CITY OF KELOWNA

MEMORANDUM

Date: October 18, 2005
File No.: **DVP05-0184**

DEVELOPMENT VARIANCE PERMIT OWNER: SUNSTONE RESORT
APPLICATION NO. DVP05-0184 COMMUNITIES CORP.

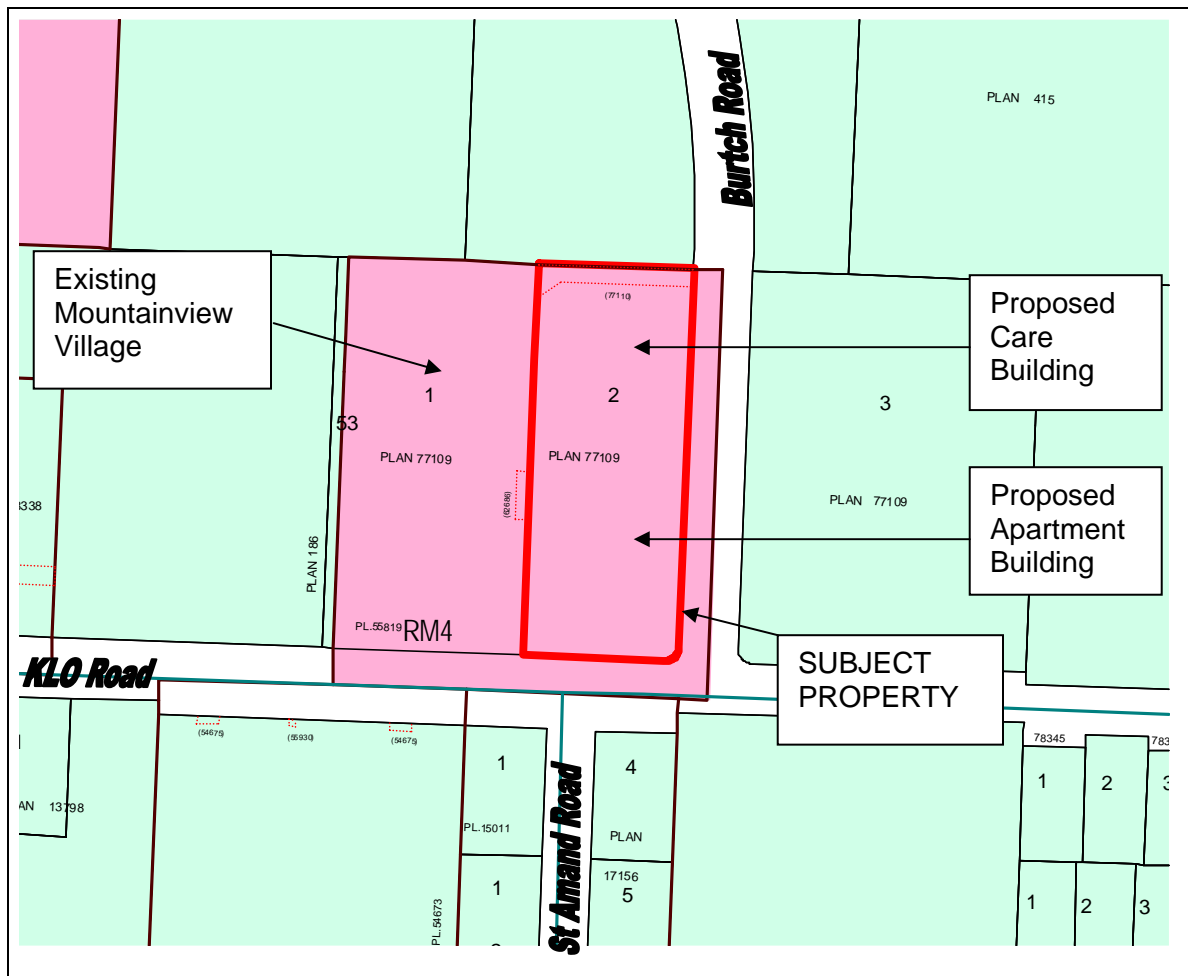
⑥ The building frontage facing Burtch Road is a 3 storey building height. The maximum length building frontage permitted for a 3 storey building is 40 m. A variance is requested for Section 13.10.7(b) **Other Regulations**, to vary the maximum continuous building frontage from 40.0 m permitted to 46.3 m. proposed for the apartment building.
